Access Compliance Report

Public Rights-of-Way

Intersection ID: 28071	Main Street: PINE_VALLEY_CLUB_DR	Cross Street: PROVIDENCE_COUNTRY_CLUB_DR	Location: S
ADA ID: AF372A83304A	Ramp Type: Perp	Initial Pass/Fail: Fail	Overall Compliance: No
Severity Score: 12.5			
Codes/Mitigation Info/Possible Solution		Field Measurements/Component Compliance

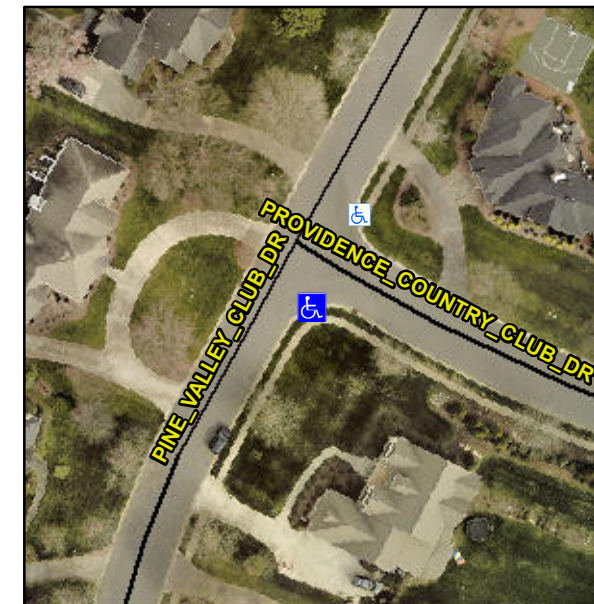
Not Found, R304.5.3

Compliance	Description	Data	Compliance	Description	Data
N/A	Ramp Length (in)	56.0	Yes	Ramp Slope (%)	5.7
Yes	Ramp Width (in)	48.0	No	Ramp XSlope (%)	6.6
N/A	Flare Type LT	N/A	N/A	Flare Type RT	N/A
N/A	Flare Slope LT (%)	N/A	N/A	Flare Slope RT (%)	N/A
N/A	Flare Traversable LT?	N/A	N/A	Flare Traversable RT?	N/A
N/A	Landing Length (in)	N/A	N/A	DWS Provided?	N/A
N/A	Landing Width (in)	N/A	N/A	DWS Contrast?	N/A
N/A	Landing Slope (%)	N/A	N/A	DWS Length (in)	N/A
N/A	Landing X Slope (%)	N/A	N/A	DWS Full Width?	N/A
N/A	Landing Curb? (Y/N)	N/A	N/A	DWS Offset (in)	N/A
N/A	Shared Landing?	N/A			
N/A	Gutter Ponding?	N/A	N/A	Gutter Slope (%)	N/A
N/A	Gutter Lip Ht (in)	N/A	N/A	Gutter X Slope (%)	N/A
N/A	Painted X Walk1?	No	N/A	Painted X Walk2?	N/A
	X Walk 1 Direction	To NE		X Walk 2 Direction	N/A
N/A	X Walk 1 Width (in)	N/A	N/A	X Walk 2 Width (in)	N/A
	X Walk 1 Slope (%)	1.2		X Walk 2 Slope (%)	N/A
	X Walk 1 X Slope (%)	3.4		X Walk 2 X Slope (%)	N/A

Remove & Replace Entire Ramp.
